HISTORIC ARCHITECTURAL REVIEW BOARD
CITY OF ALLENTOWN
December 15, 2021
FINAL REVIEW

Property located at: 809 -811 W. Gordon St.

Agenda Item: #2.a

Case: HDC-2021-00031/32

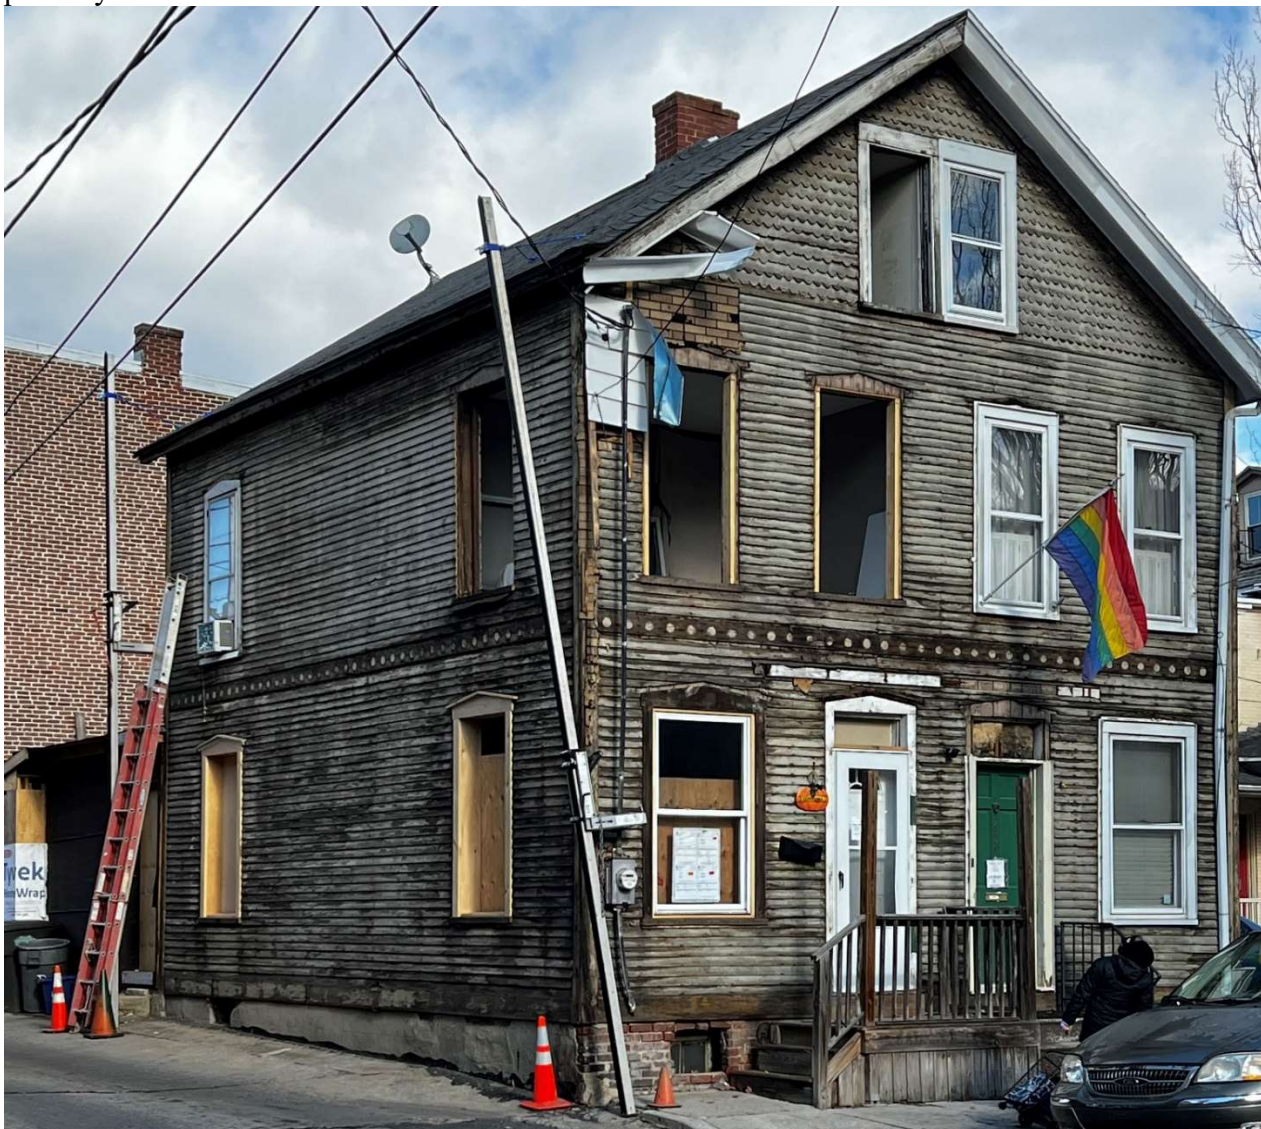
The work proposed under this application will repair and restore existing historic materials. The proposed restoration of the existing wood siding is appropriate and encouraged. The new window and door surrounds are based on physical evidence on the building and are an appropriate reconstruction of missing features. The two attached buildings will be restored to a more united exterior appearance, which is appropriate as they were constructed as a pair. The proposed light fixtures (one at each entrance) are historically appropriate wall sconce lantern types. Restoration of the transom windows above each door is appropriate; no lite or configuration description was submitted, so single-lite transoms are appropriate based on the existing openings and lack of other documentation. The replacement of the entry stairs with a new tandem stair appears to be an appropriate alteration; the existing wood and concrete stairs do not appear to be historic materials and are not character-defining features of the property. At 811 W. Gordon, the proposed replacement of a non-original front door with a new wood front door with 6-panel configuration to match the existing historically appropriate door at 809 W. Gordon is appropriate.

Overall, the proposed project appears to be appropriate. It is recommended by the HARB to include adding weepholes to the porch construction, confirm the concrete porch will have a brick veneer, the design of the new handrail should match the existing gate not the extant railing, the new door, transom and trim for #809 should match the same on #811.

AJ-asked why secondary door was being removed. Owner confirmed it a non-functioning door not on a primary façade and the infill would be preferred by the owner.

Front Door of #811 to match the 6 panel Colonial door and custom make the transom with the numbers in the transom above at #809.

AJ asked for clarification on how stair would be rebuilt., Owner referenced another property (814 W Gordon) as a precedent example with brick veneer on the stoop. Concrete with bullnose treads.

AJ noted the proposed railing is inappropriate to this building, GL agreed, noted the extant wrought iron gate is more appropriate to use as a precedent for the new railing design. GL suggested the new railing meet code and it is preferred if the spacing and shape were more similar to the gate versus the extant railing there now.

A motion to approve the application as presented with conditions including incorporate weepholes into the porch, concrete shall be faced with brick, railing details to be round or square with closer spacing, new door to match 809, new light fixture presented will be used at both 809 & 811 addresses was made by HARB Chair David Huber, motion was seconded by HARB member AJ Jordan. Motion carried with unanimous support.
